# LHAM2

# LHAM2

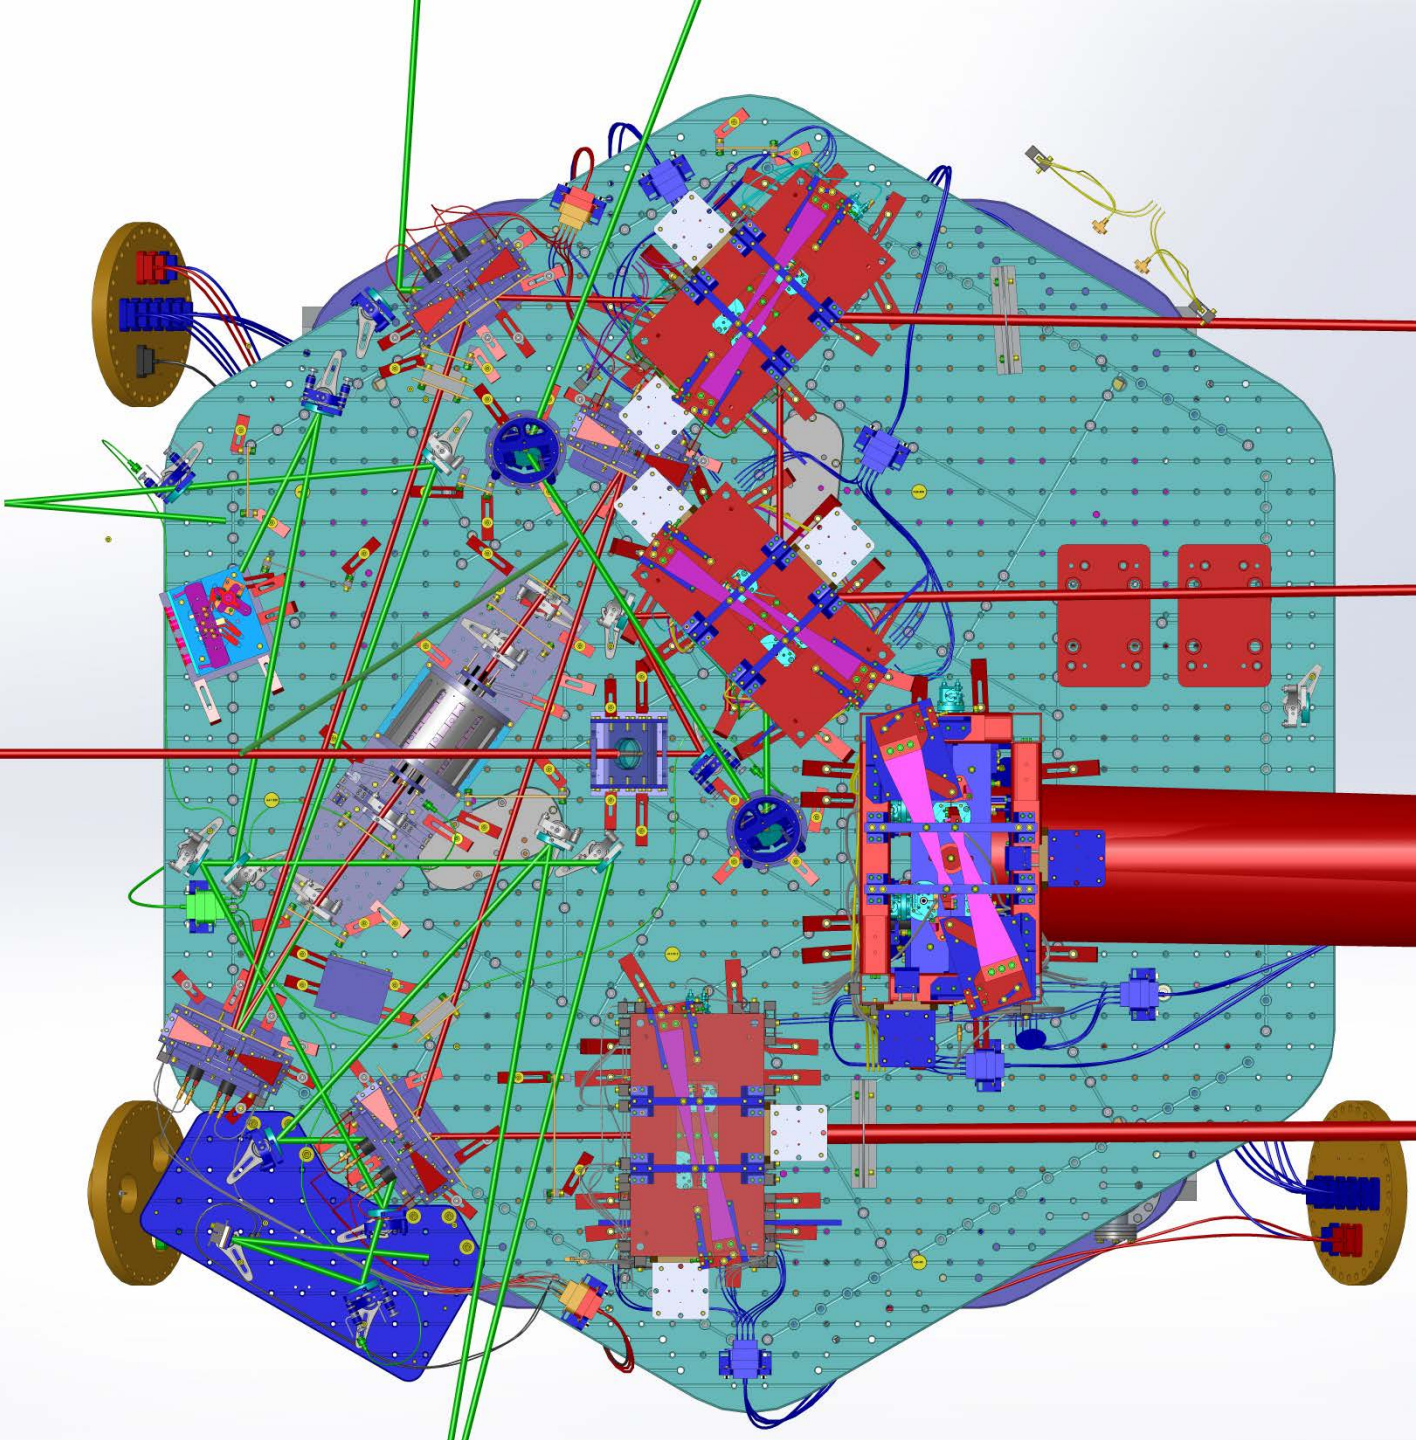
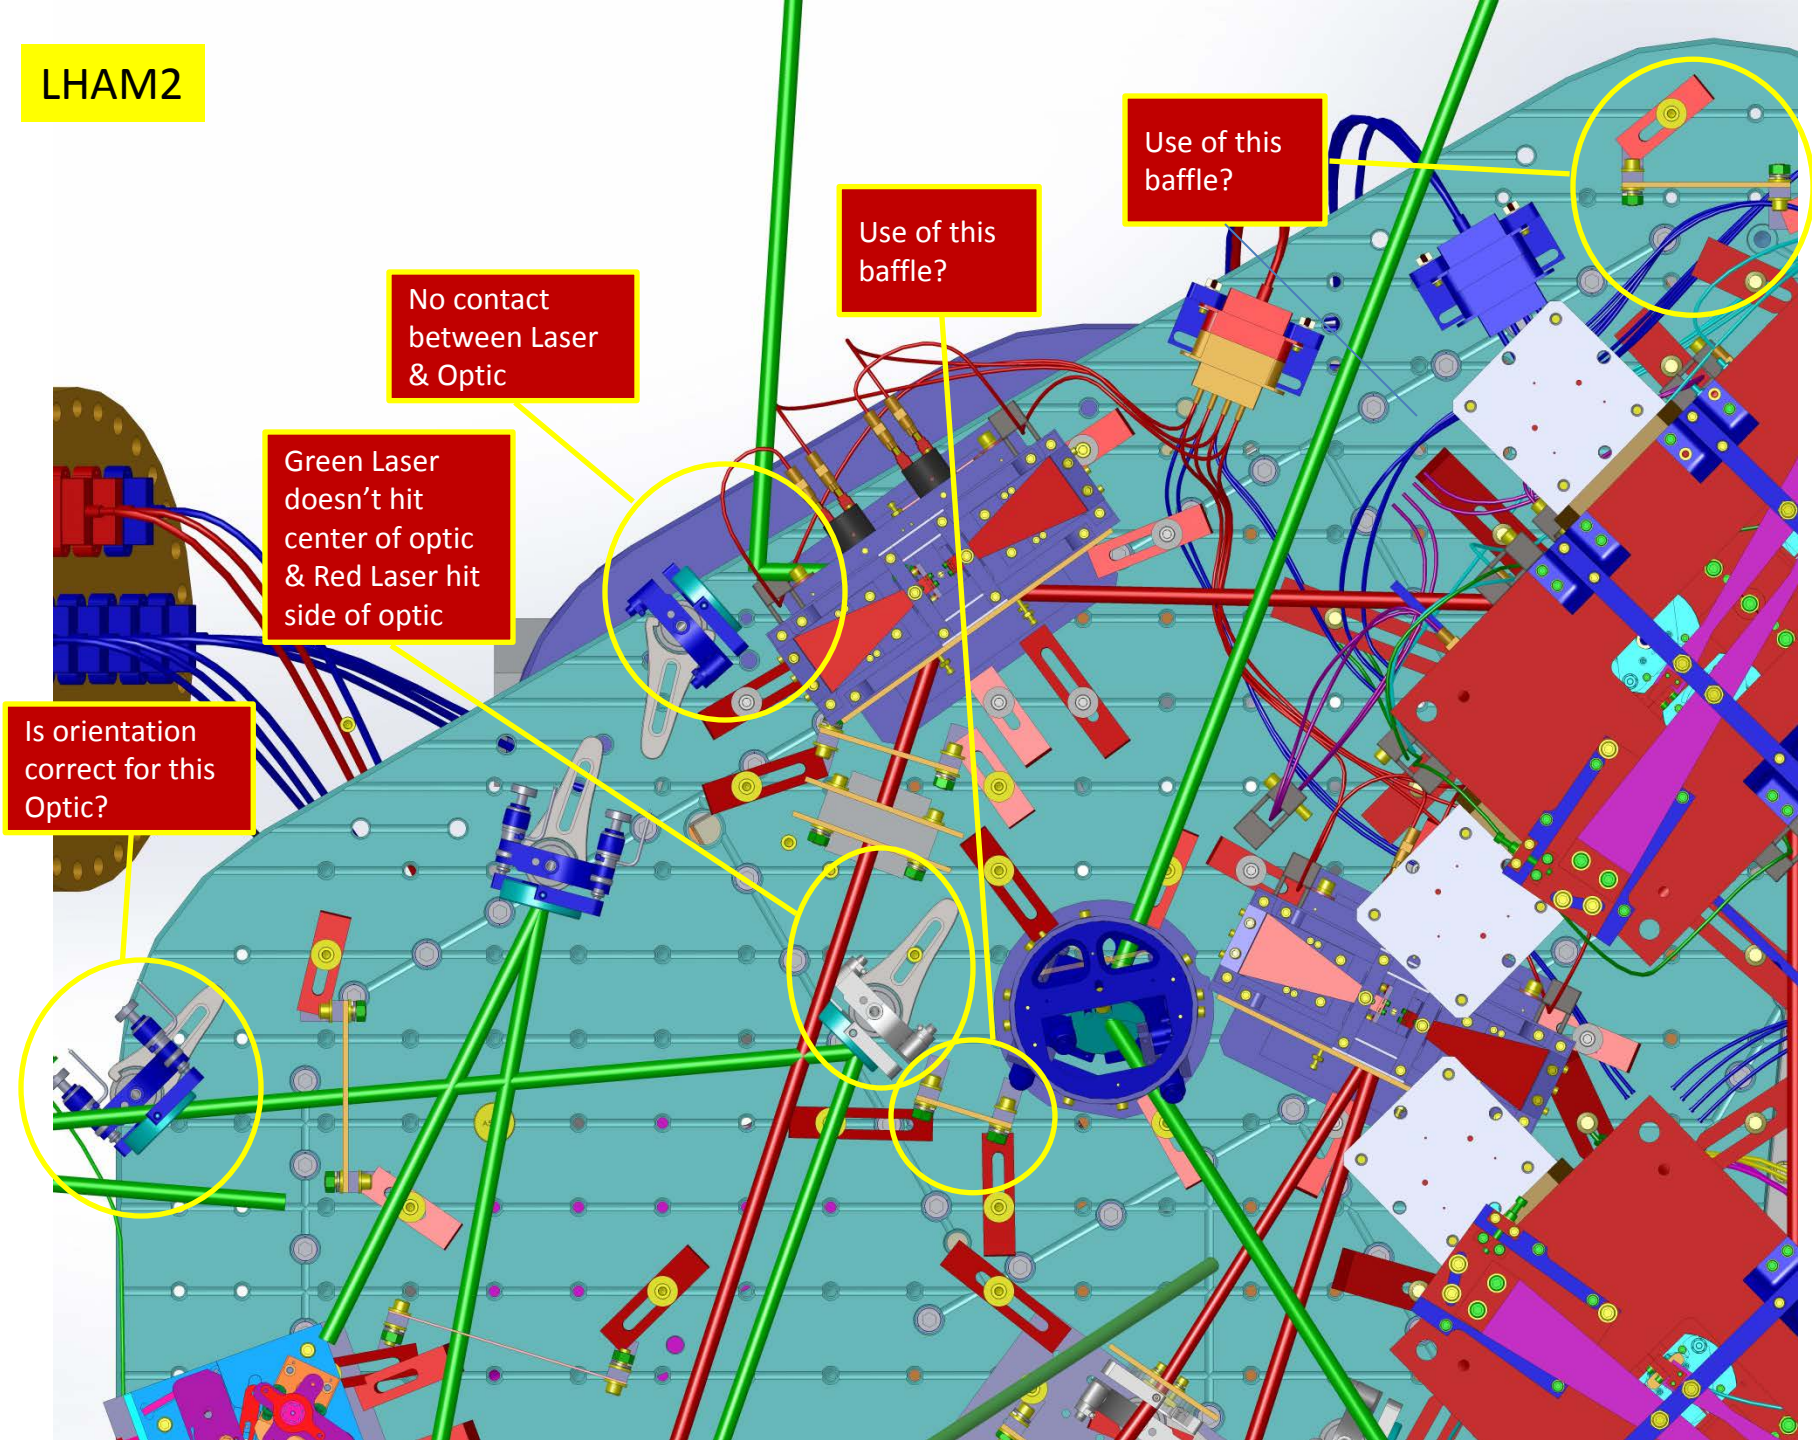
No contact between Laser & Optic

Green Laser doesn't hit center of optic & Red Laser hit side of optic

Is orientation correct for this Optic?

Use of this baffle?

Use of this baffle?

LHAM2

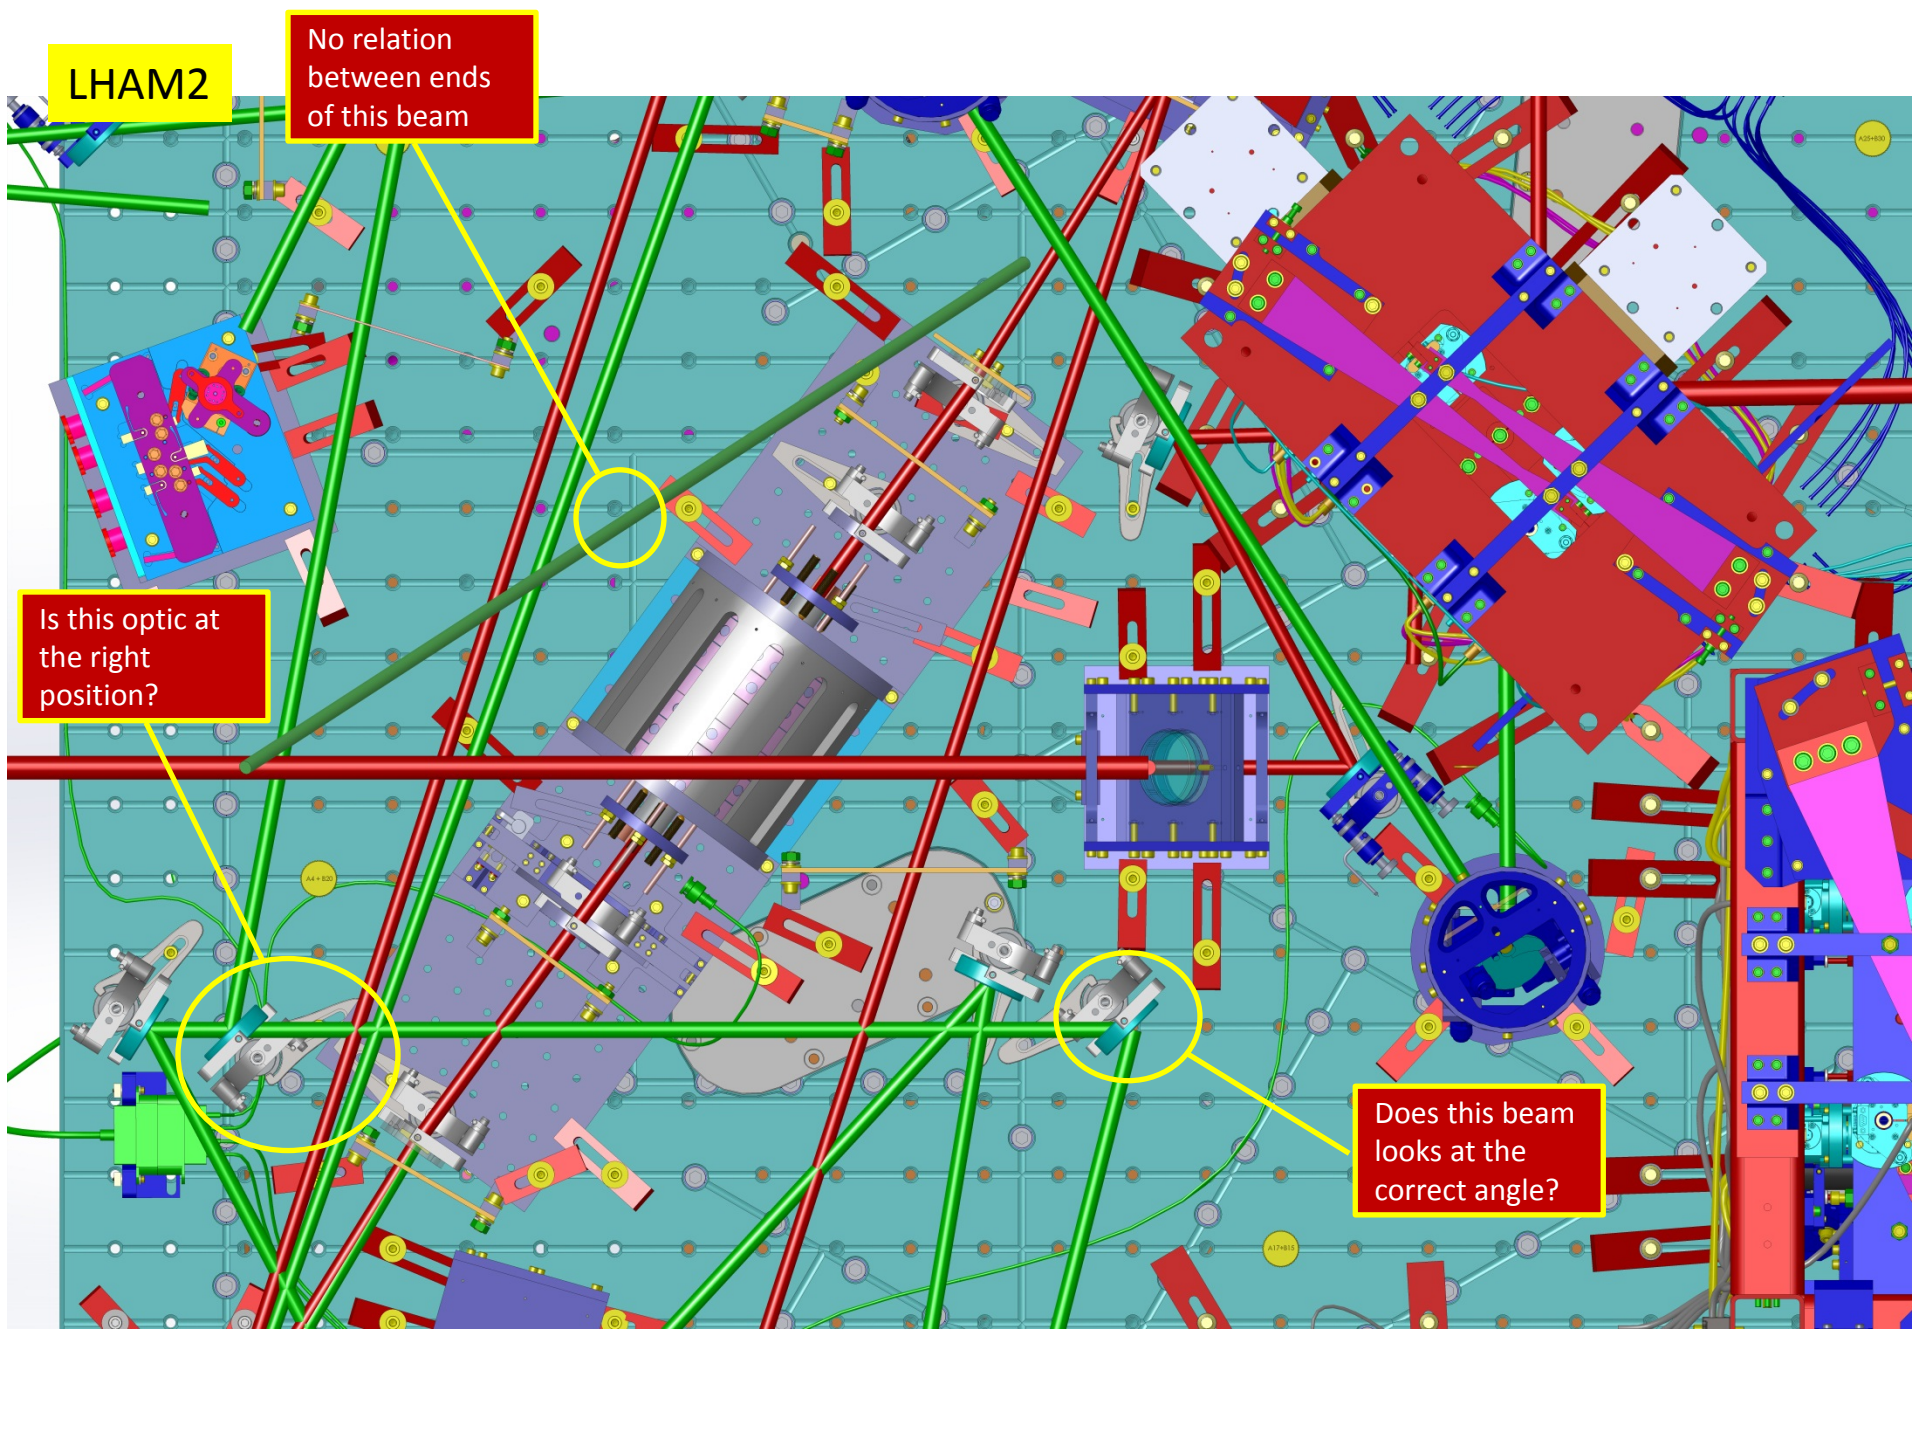
No relation  
between ends  
of this beam

Is this optic  
at  
the right  
position?

Does this beam  
look at the  
correct angle?

LHAM2

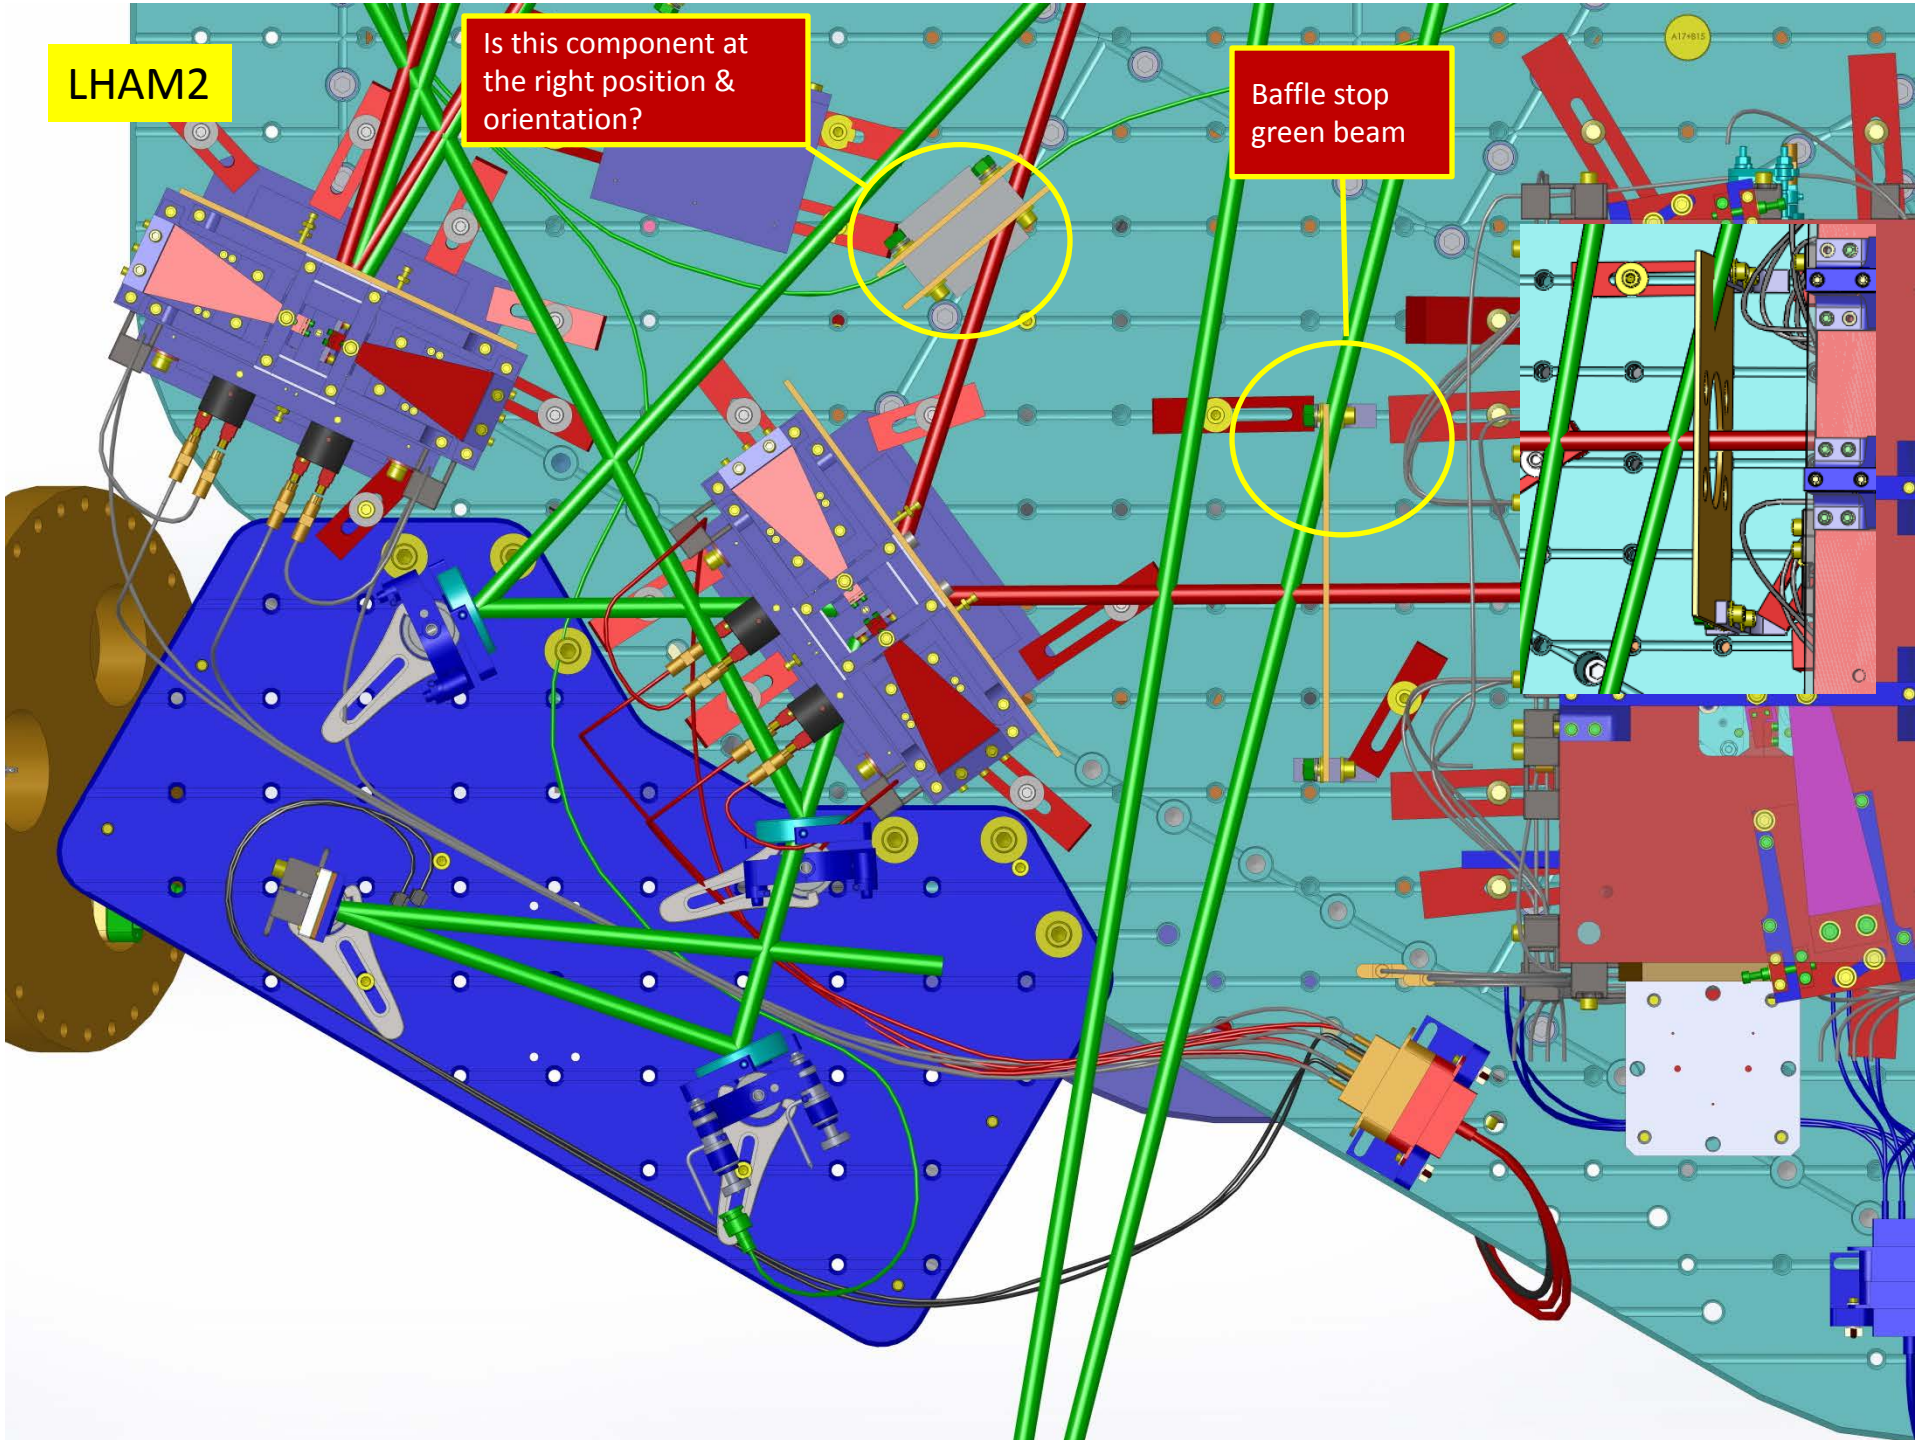
Is this component at the right position & orientation?

Baffle stop green beam
